# MISSISSIPPI POWER & LIGHT COMPANY

June 22, 1984

SUBJECT: Grand Gulf Nuclear Station  
Unit 1  
Docket No. 50-416  
License No. NPF-13  
File 0260/0840/L-860.0  
Proposed Amendment to the  
Operating License  
(PCOL's-84/11B, 13D, 14C,  
and 16)  
AECM-84/0319

FIGURE 4.7.4-1  
 SAMPLE PLAN 2) FOR SNUBBER FUNCTIONAL TEST

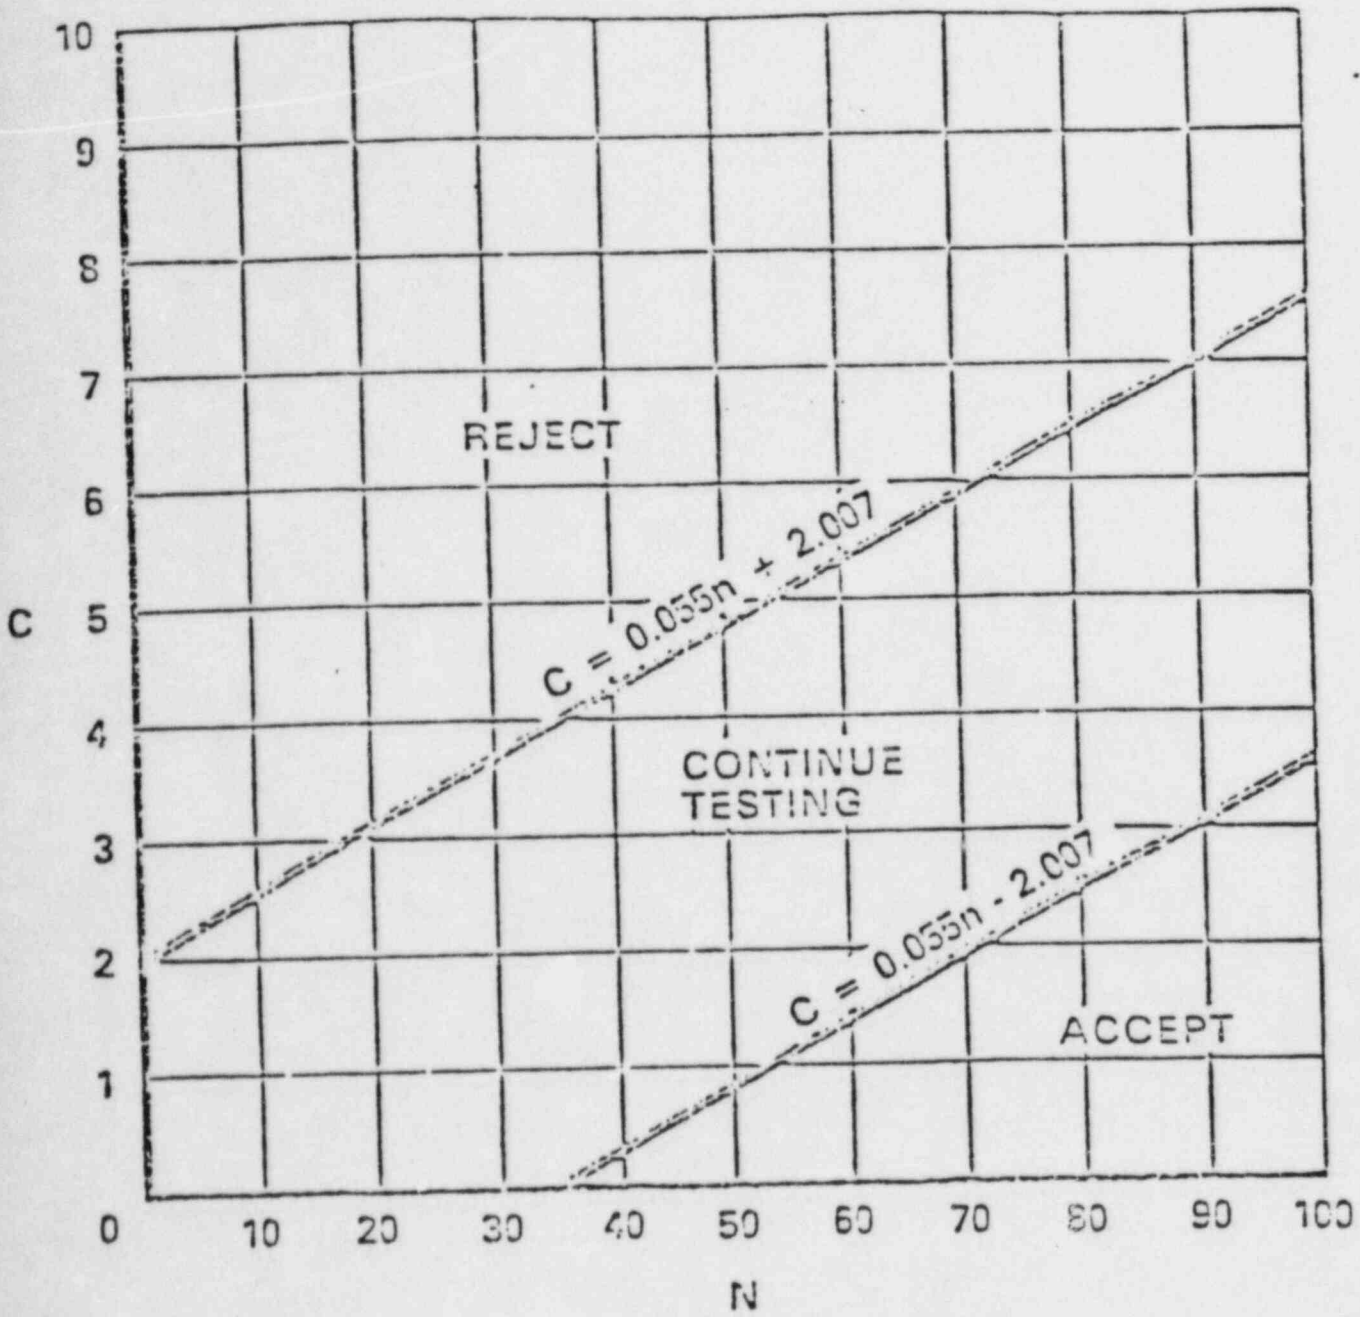
- k. Figure 4.7.4-1 is added to the surveillance requirement to be used when Surveillance Requirement 4.7.4.e.2 is chosen as the option for functional testing of the snubbers. This figure was developed using "Wald's Sequential Probability Ratio Plan" as described in "Quality Control and Industrial Statistics" by Acheson J. Duncan. This reference is included in the bases.

- 2) A representative sample of each type of snubber shall be functionally tested in accordance with Figure 4.7.4-1. "C" is the total number of snubbers of a type found not meeting the acceptance requirements of Specification 4.7.4f. The cumulative number of snubbers of a type tested is denoted by "N". At the end of each day's testing, the new values of "N" and "C" (previous day's total plus current day's increments) shall be plotted on Figure 4.7.4-1. If at any time the point plotted falls in the "Reject" region all snubbers of that type shall be functionally tested. If at any time the point plotted falls in the "Accept" region, testing of snubbers of that type may be terminated. When the point plotted lies in the "Continue Testing" region, additional snubbers of that type shall be tested until the point falls in the "Accept" region or the "Reject" region, or all the snubbers of that type have been tested. Testing equipment failure during functional testing may invalidate that day's testing and allow that day's testing to resume anew at a later time, providing all snubbers tested with the failed equipment during the day of equipment failure are retested; or
